# TECHNICAL NOTE

REF: 301404162

DATE: 22 December 2021

### PARKSIDE YERONGA – COMMERCIAL DEVELOPMENT PROPOSAL

**SWEPT PATH ASSESSMENT - LOWER GROUND LEVEL  
SERVICE VEHICLE AND RAMP MANOEUVRING**

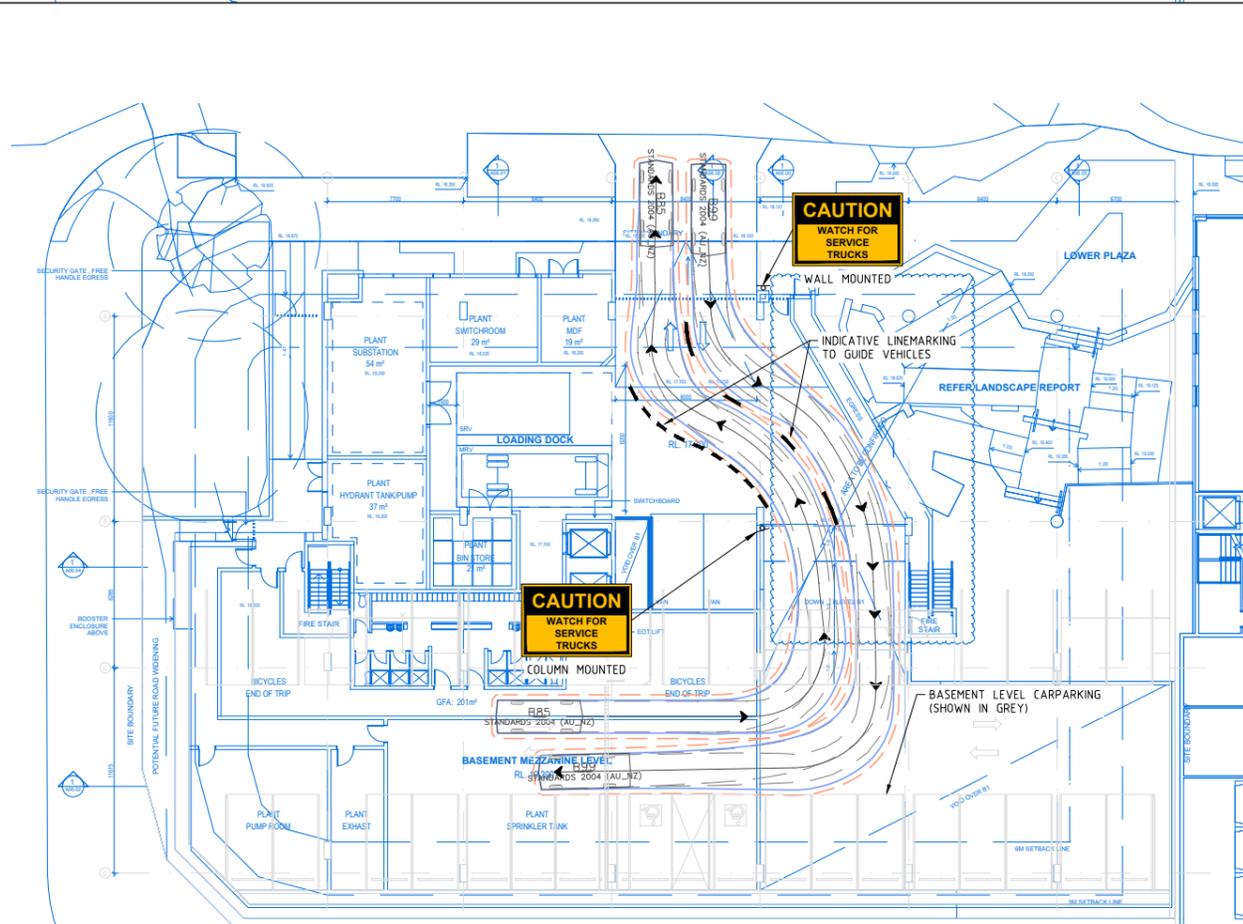
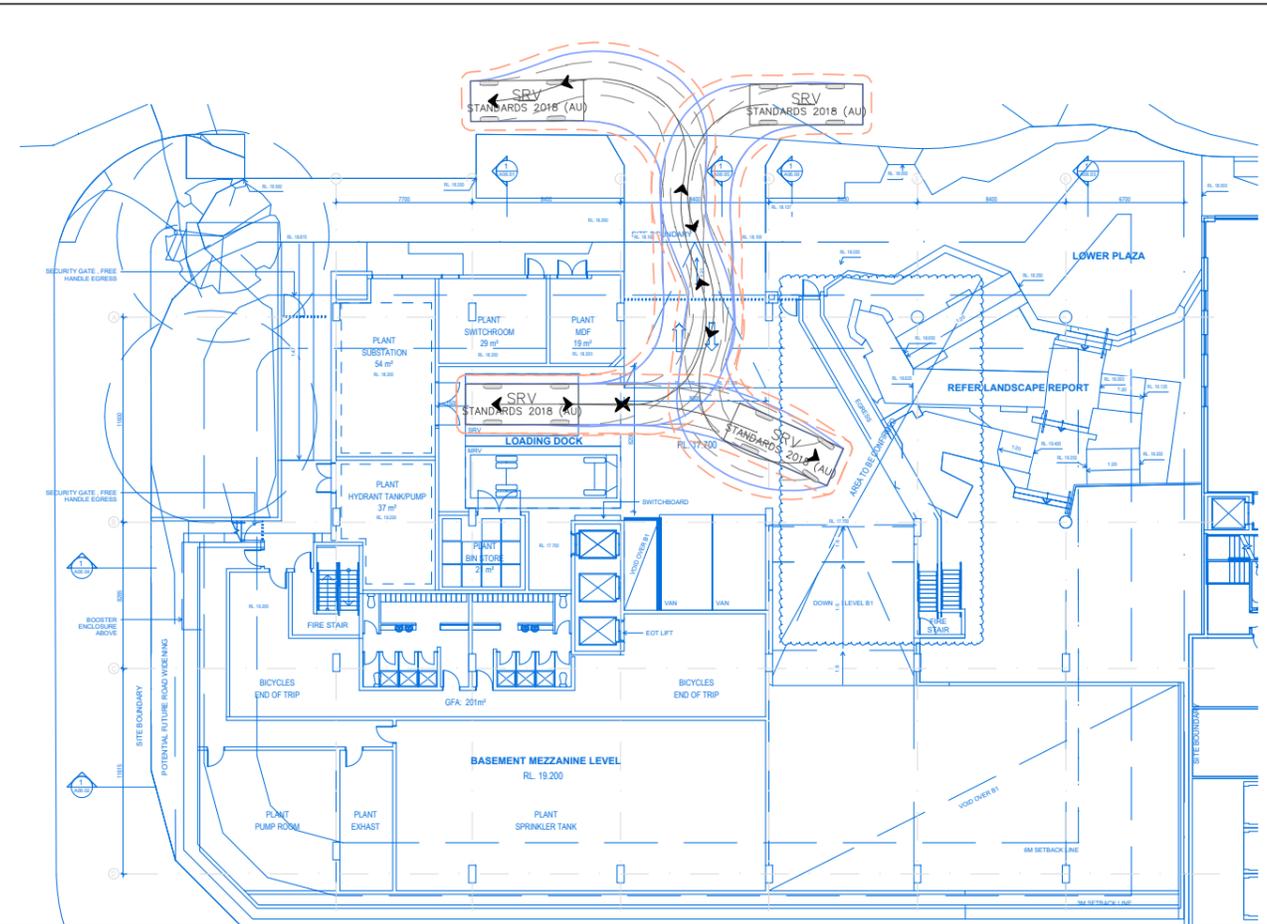
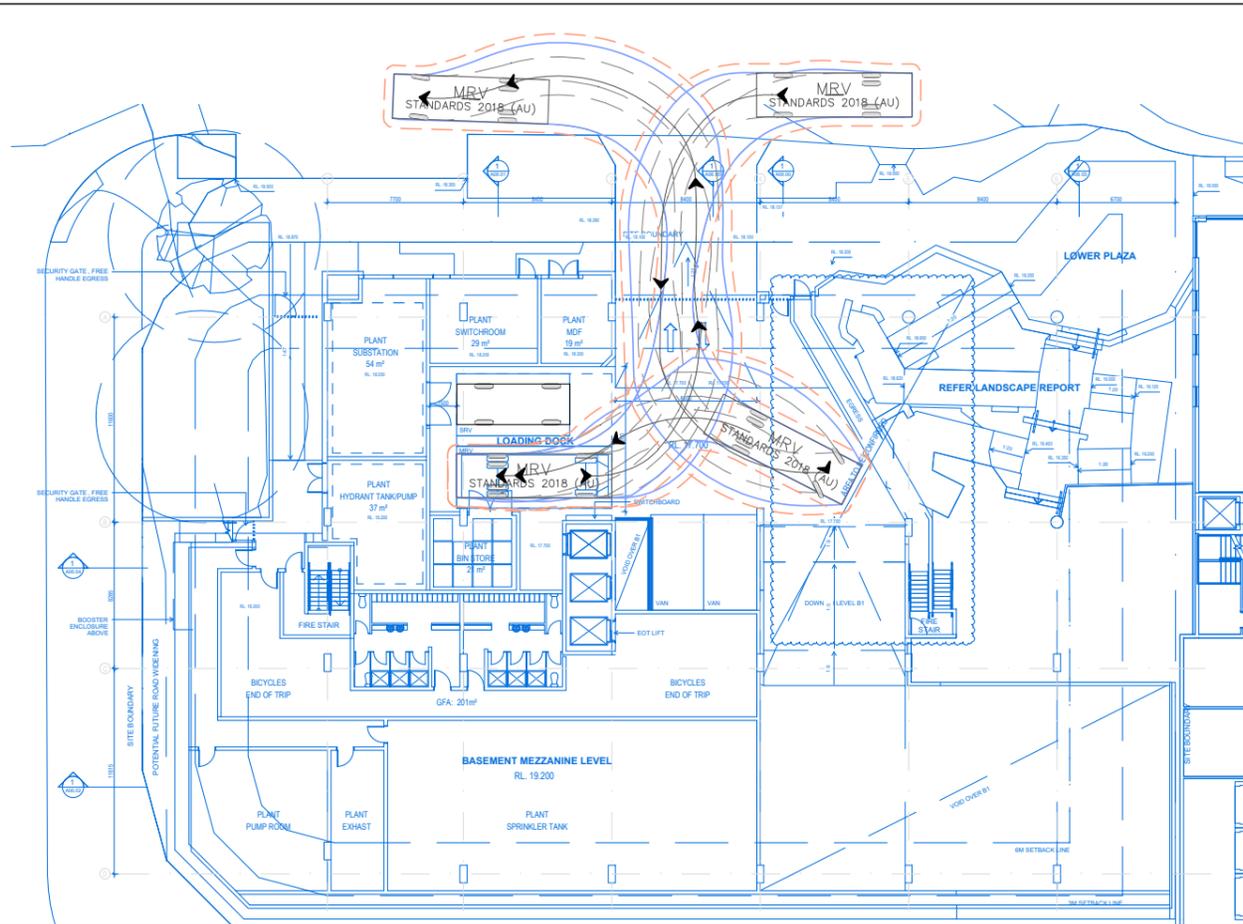
Based on Council’s TAPS PSP, the minimum servicing design vehicle for the proposed development use as a Medium Rigid Vehicle (MRV). Loading bay access and internal circulation has been designed, and tested by way of a swept path assessment, for vehicle of a size up to and including an 8.8m long MRV. Based on the swept path assessment, an 8.8m MRV can successfully circulate throughout the site access, manoeuvre into the loading bay and depart the site without conflicting with any adjacent walls or vehicles. This swept path is provided within Attachment B.

The vehicle crossover and accessway are provided as per the Parkside Yeronga Master Plan. As such vehicle crossover has been designed based on its anticipated use (i.e. service vehicle and passenger vehicle use, minor road frontage, low / medium car parking turnover rate, staff and visitor car parking, less than 250 car parking spaces) providing two-way movement and accommodating access for a MRV design vehicle. The vehicle access has been tested by way of a swept path assessment for vehicle of a size up to and including an 8.8m long MRV. This swept path is provided within Attachment B.

It is recommended that any deliveries by the MRV be managed to avoid peak period operations of the proposed Commercial Development to minimise conflicts with staff and visitors entering and exiting the car parking areas. This can be managed by way of a Loading Dock Management Plan and delivered by way of a suitably worded Condition of Approval.
